UNITED STATES PATENT AND TRADEMARK OFFICE

APPLICATION NO.	FILING DATE	FIRST NAMED INVENTOR	ATTORNEY DOCKET NO.	CONFIRMATION NO.
10/593,039	09/30/2008	Linda Menrik	69409.001017	5751
21967	7590	01/20/2010	EXAMINER	
HUNTON & WILLIAMS LLP			SCRUGGS, ROBERT J	
INTELLECTUAL PROPERTY DEPARTMENT				
1900 K STREET, N.W.			ART UNIT	PAPER NUMBER
SUITE 1200				3723
WASHINGTON, DC 20006-1109				
			MAIL DATE	DELIVERY MODE
			01/20/2010	PAPER

DETAILED ACTION

Fig. 3D

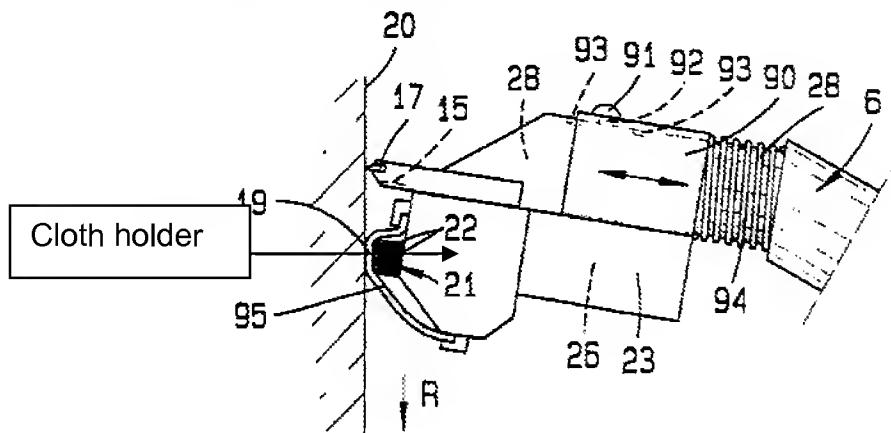
In reference to claims 8, 15 and 17, Delgado et al. also teach that a cloth holder (see figure below) can be provided with said liquid distributing means (21). It would have been obvious to one of ordinary skill in the art to modify the cloth holder, of Parker et al., with the known liquid distributing means, as taught by Delgado et al., and the results would have been predictable. In this situation, one could provide a continuous supply of

cleaning liquid onto a cloth thereby more effectively cleaning various surfaces while also enabling continuous working on said surfaces in one operation.

In reference to claim 9, Delgado et al. also show that the liquid container (23) is an integrated part of said cloth holder (see figure above).
